TO: District of Columbia Zoning Commission

DATE: May 4, 2015

SUBJECT: ZC 14-14 – Final Report Consolidated PUD and Related Map Amendment
501 H Street NE (Square 833, Lot 47).

Ground Floor Plan:

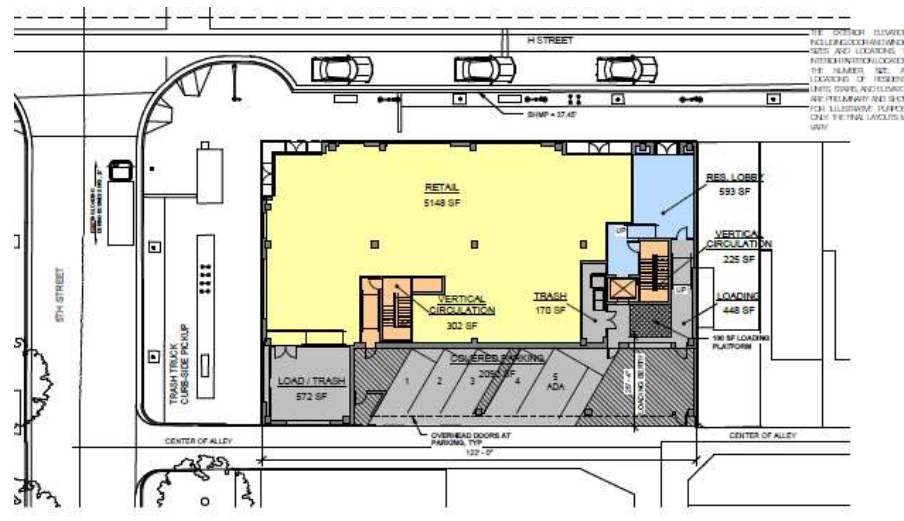
The ground floor plan has been simplified over its initial concept. A more orderly and efficient layout is presented in the current design, including clearly defined areas for residential and retail trash and loading functions and circulation within the building. The inclusion of angled parking off the rear alley would facilitate ingress and egress given the alley's narrow width. It also negates the need to utilize parking spaces for truck turning movements, as previously proposed (*Exhibit 26A: pgs. 14 & 37*). A parking space was removed to include a handicapped space and all spaces would be compact, with a space assigned to a car share company.

Site Sustainability:

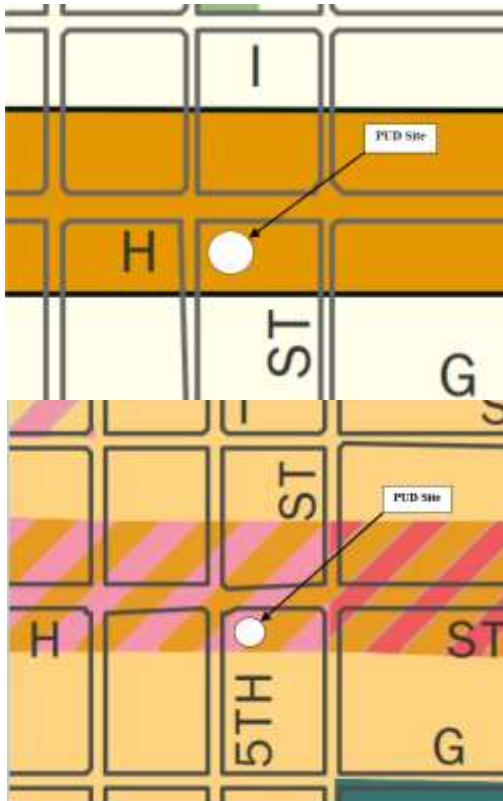
Previously, a green screen was proposed at the rear, but was replaced to facilitate covered parking at grade level, at the ANC's request. The area of the green roof has been increased from 3,614 sf. to 3,813 sf. and a 1,044 sf. bio-retention facility has been included, where none previously existed. The applicant was also encouraged to revise its LEED certification and LEED Gold-equivalent is now proposed.
